RE: **6104 Pojoaque St NW**
Grading and Drainage Plan
Engineer's Stamp Date: 4/25/19
Drainage File: E10D063

Based on the submittal received on 4/26/19, the grading and drainage plan is approved for Grading Permit and Building Permit.

ENGINEER'S SEAL	6104 POJOAQUE LOT 2 BLOCK 4B VOLCANO CLIFFS UNIT 3	DRAWN BY JDG
	GRADING AND DRAINAGE PLAN	DATE 04/26/2019
4/25/19	 <i>Rio Grande Engineering</i> 1606 CENTRAL AVENUE SE SUITE 201 ALBUQUERQUE, NM 87106 (505) 972-0999	SHEET # 1 OF 1
DAVID SOULE P.E. #14522		JOB #

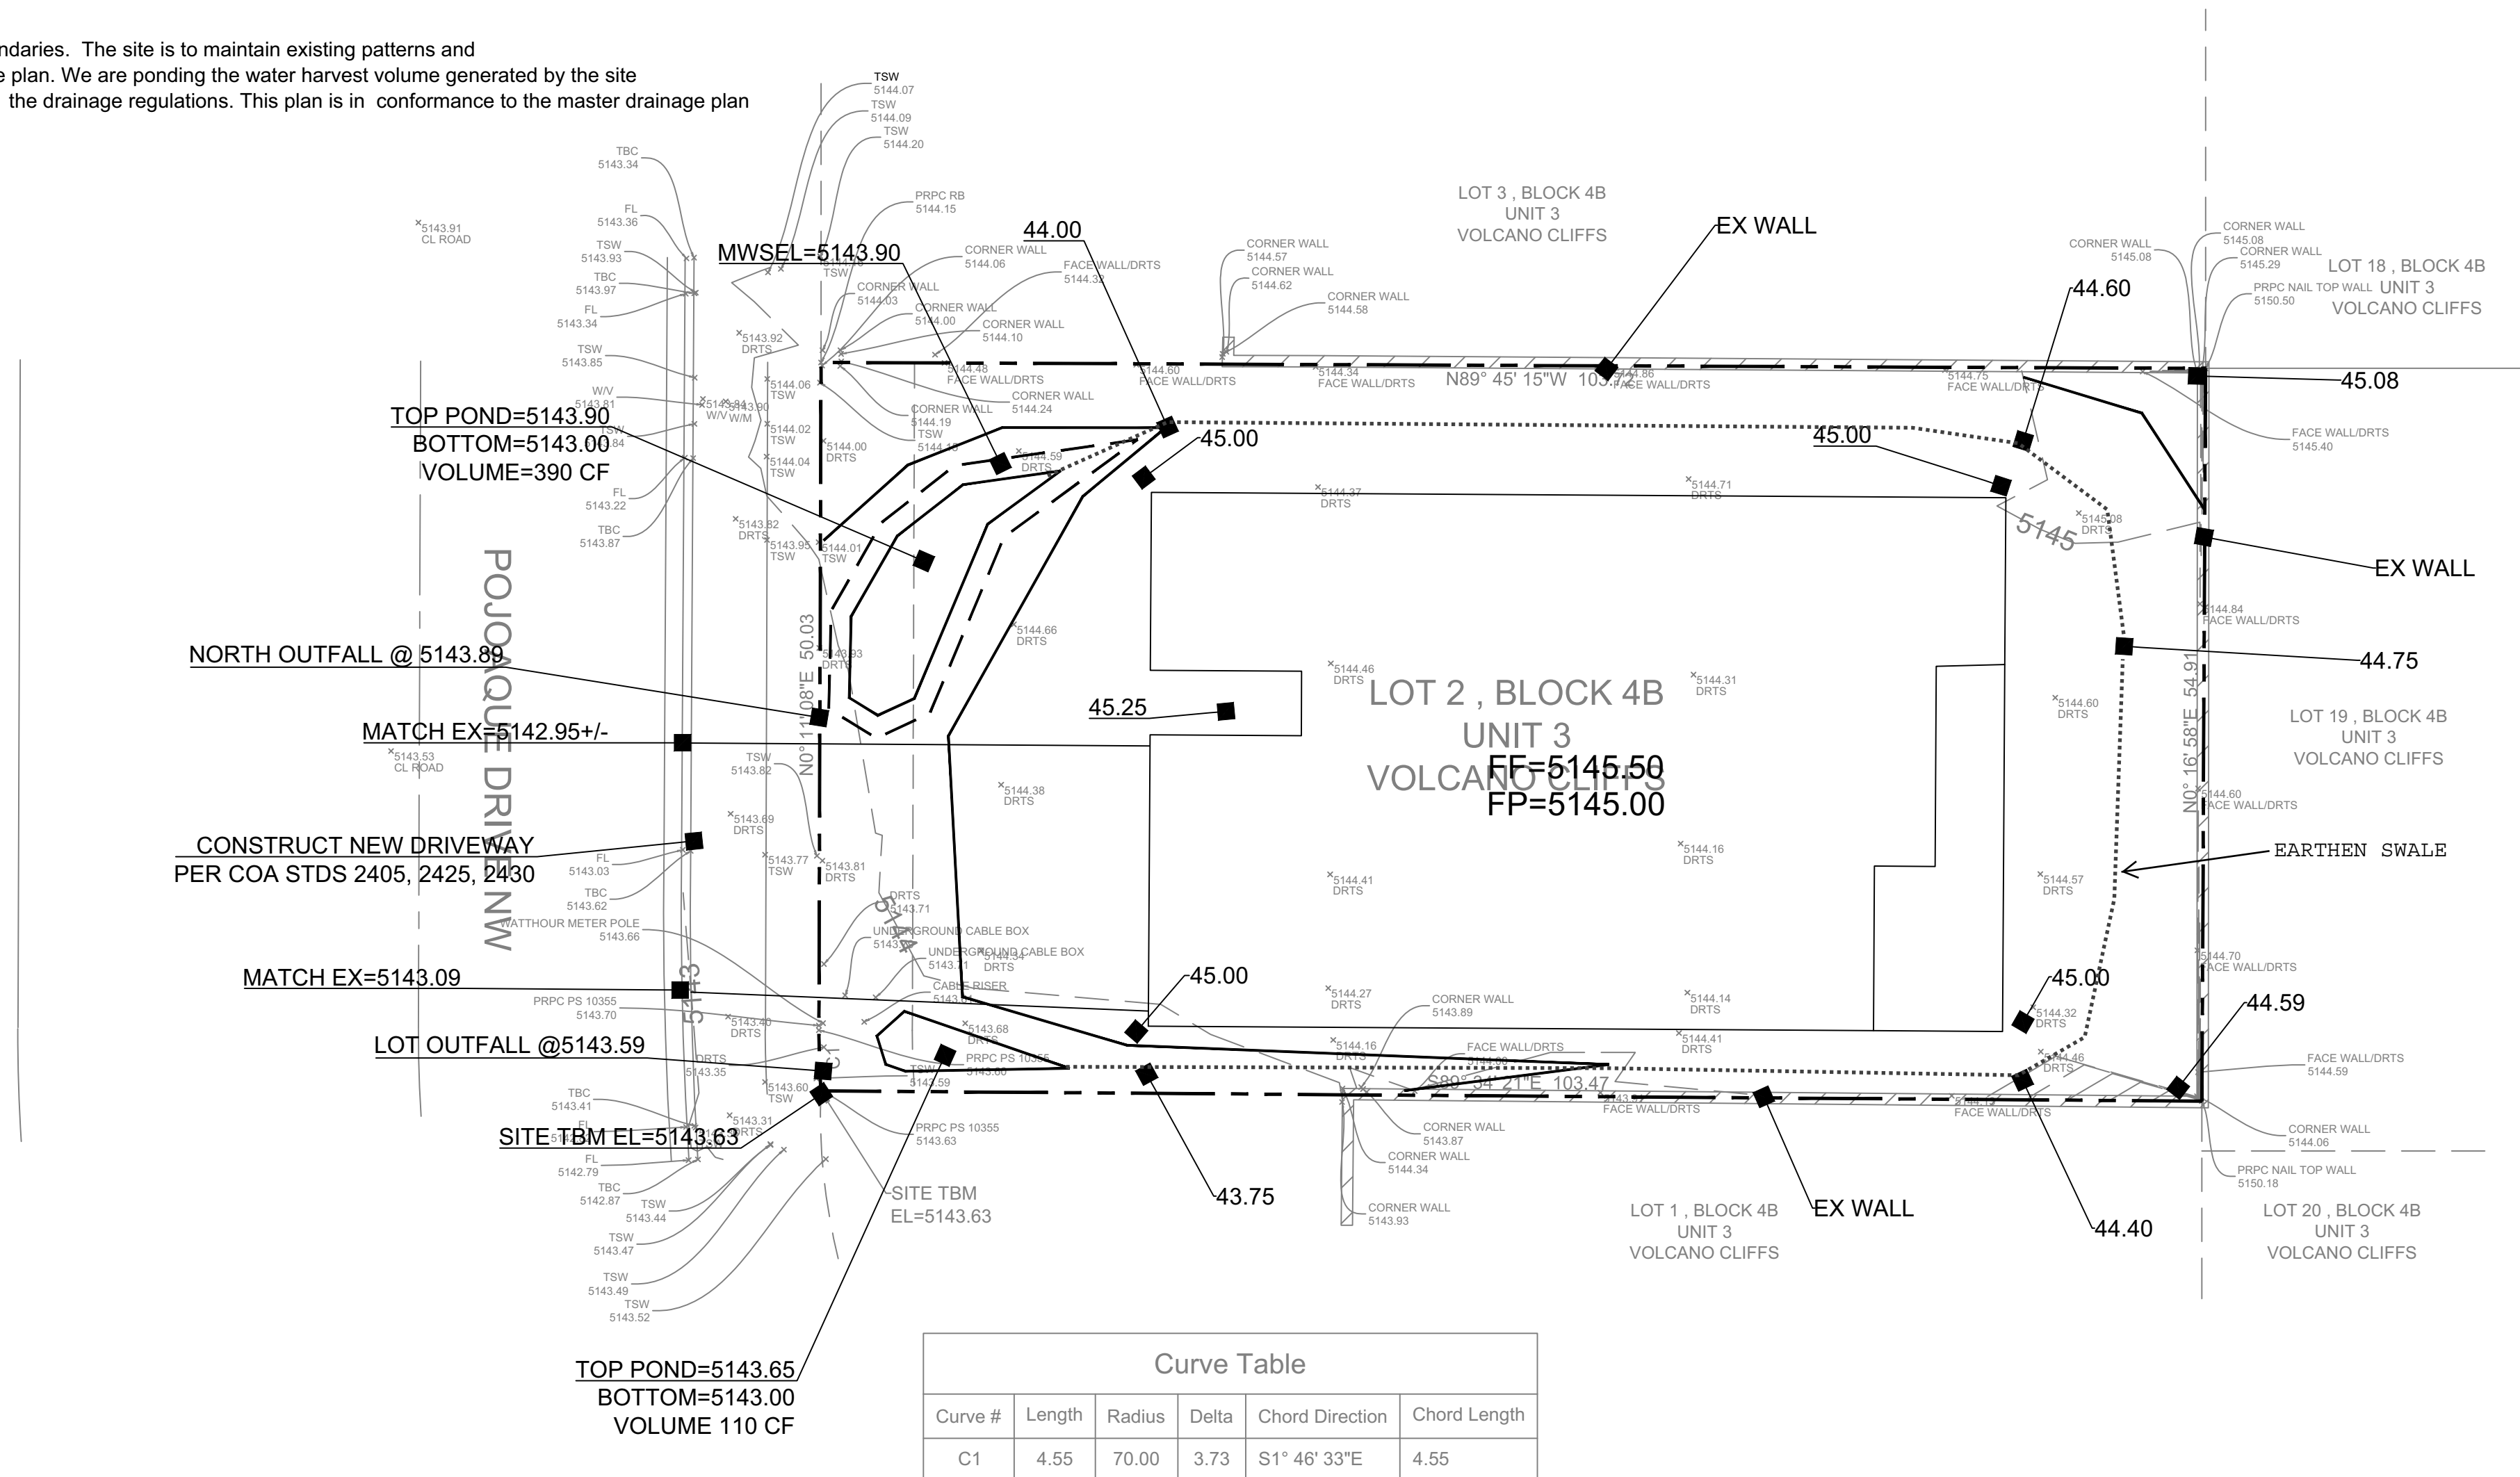
1. Engineer's Certification, per the DPM Chapter 22.7: *Engineer's Certification Checklist For Non-Subdivision* is required to ensure the grades along the property lines were not disturbed during home construction.
